Nine Mile Point
Nuclear Station

SUBJECT: Nine Mile Point Unit 1
Docket No. 50-220

Request for Additional Information (RAI) - Amendment
Application Re: Pressure-Temperature Limit Curves
(TAC Nos. MB6687 and MB6703)

**Response
to
NRC Request
for
Additional
Information:
Nine Mile Point
Unit 1
P-T Limit
Curves**

Figure 3-1 Average Fluence Rate for NMP-1 for Cycle 9 as a Function of Azimuthal Angle at the Maximum Axial Height Calculated Using Neutron Source Data from ORIGEN and from Casmo-Simulate

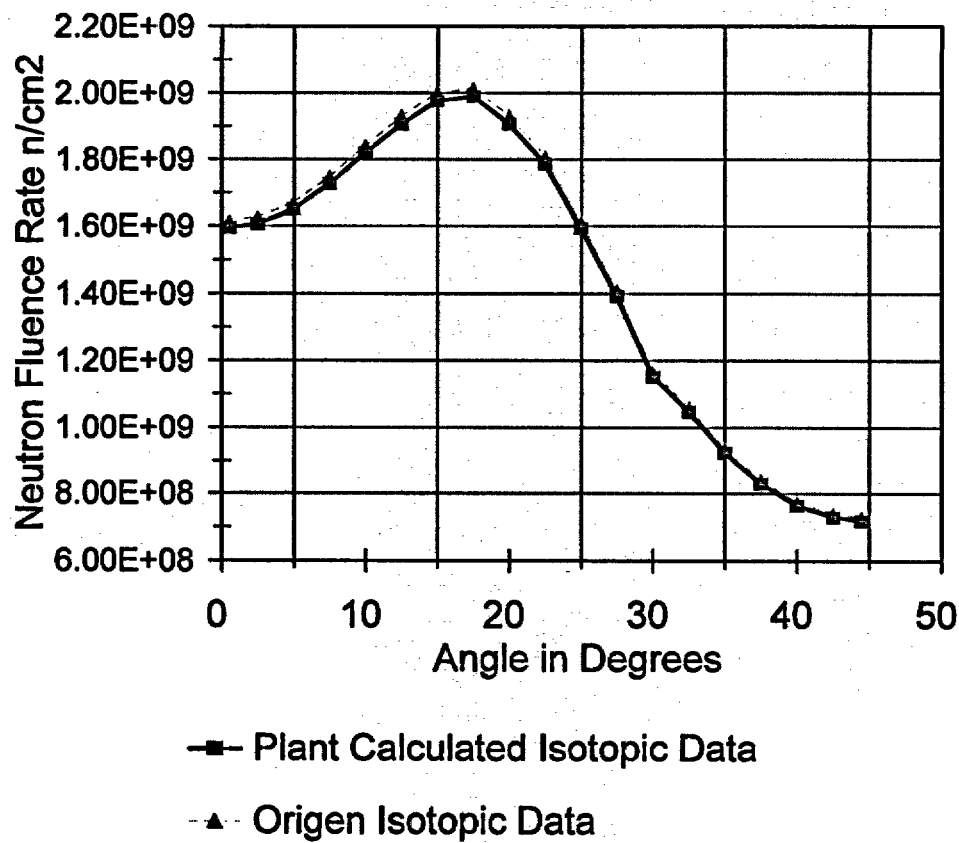
Benchmarking - The licensee derived the neutron sources using the power distribution and the ORIGEN 2.1 code. It is not clear to the NRC staff why this code was used since fuel composition as a function of burnup should be available from reload reports. Please justify the derivation of the source. For example, calculate a cycle for which you know the source would compare with results using ORIGEN 2.1.

Benchmarking - The licensee derived the neutron sources using the power distribution and the ORIGEN 2.1 code. It is not clear to the NRC staff why this code was used since fuel composition as a function of burnup should be available from reload reports. Please justify the derivation of the source. For example, calculate a cycle for which you know the source would compare with results using ORIGEN 2.1.

derived neutron source was higher by about 0.6%. Results for the two calculations are shown in Figure 3-1 which presents the neutron flux above 1 MeV at the vessel inner radius at the maximum axial elevation. It is observed that the curves are in close agreement, with the ORIGIN source producing a calculated fluence rate that is uniformly higher by 1.3%. Thus the effect of the difference in neutron spectrum is about 0.7% when the 0.6% difference in normalization is subtracted.

The 1.3% difference may be compared with the estimated uncertainty in vessel fluence due to the spectrum and normalization uncertainty previously evaluated for NMP-1 in Reference [2]. This estimate was 2.9% for the vessel inner radius maximum fluence rate. Thus, the difference between ORIGIN and Casmo-Simulate sources falls well within the previously estimated uncertainty. Moreover, it should be noted that the ORIGIN result differs in a conservative direction, i.e. use of the ORIGIN data produce a higher calculated exposure.

Based on these results, it is concluded that the use of ORIGIN to determine the fraction of fissions from fuel isotopes is acceptable in lieu of using plant-specific data from fuel depletion codes. If ORIGIN is used, differences within the range of burnups considered are less than estimated uncertainties in results arising from the uncertainties in neutron spectrum and source normalization, and the error is in a conservative direction.

Figure 5-1 Nine Mile Point Unit 1 R-θ Geometry Used in the DORT Calculations

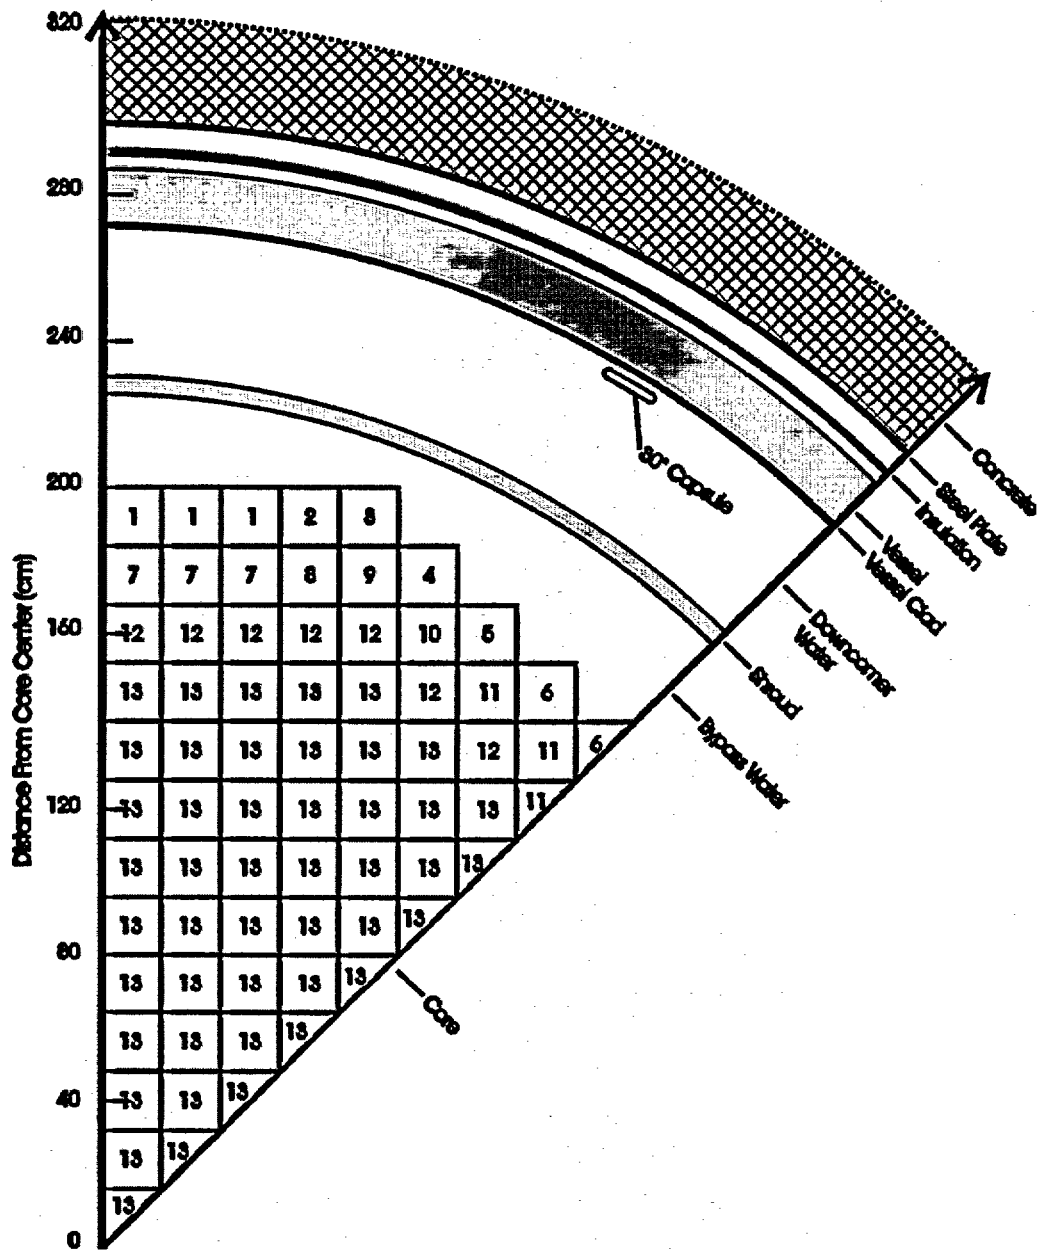
Surveillance Capsules Used in the Proposed Benchmarking - The licensee removed, tested, and analyzed a total of five surveillance capsules from both Nine Mile Point units. However, only two capsules were used in the submitted benchmarking analysis. As stated in RG 1.190, one of the objectives of benchmarking is to determine potential bias in the calculation of the best-estimate which requires that all of the existing data be used. The licensee ignored the existence of three Nine Mile Point capsules and made no effort to determine the existence of a bias. The benchmarking effort appears incomplete.

Surveillance Capsules Used in the Proposed Benchmarking - The licensee removed, tested, and analyzed a total of five surveillance capsules from both Nine Mile Point units. However, only two capsules were used in the submitted benchmarking analysis. As stated in RG 1.190, one of the objectives of benchmarking is to determine potential bias in the calculation of the best-estimate which requires that all of the existing data be used. The licensee ignored the existence of three Nine Mile Point capsules and made no effort to determine the existence of a bias. The benchmarking effort appears incomplete.

To perform the dosimetry analysis, updated models of the NMP-1 reactor were constructed. These models include the latest information available on the reactor geometry. Changes from earlier models include the use of plant specific data on regions above and below the core and definition of the regions beyond the vessel into the biological shield. Moreover, a more precise definition of the outer core edge and outer row of fuel bundles was incorporated into the model.

The R-θ model is shown in Figure 5-1. The model included 176 mesh points in the radial direction covering the range from the center of the core to about 12 inches into the concrete biological shield. In the azimuthal direction, 66 mesh points were used to model a single octant of the reactor. Inspection of the fuel loading patterns indicated that only minor deviations from an octant symmetry were present and thus use of a single octant in the model was justified. The core region used a homogenized material distribution which includes the fuel, fuel cladding, and the water. The water region in the fuel was divided into two parts: one with the water in the fuel bundle outside the pins, and one that included the water in the water pins and water in the channels outside the fuel bundle. The latter water was assumed to be all at the base water density with no steam fraction. The other water volume contains both liquid water and steam. The fraction occupied by steam is known as the void fraction and varies by fuel bundle and by axial position within the fuel bundle.
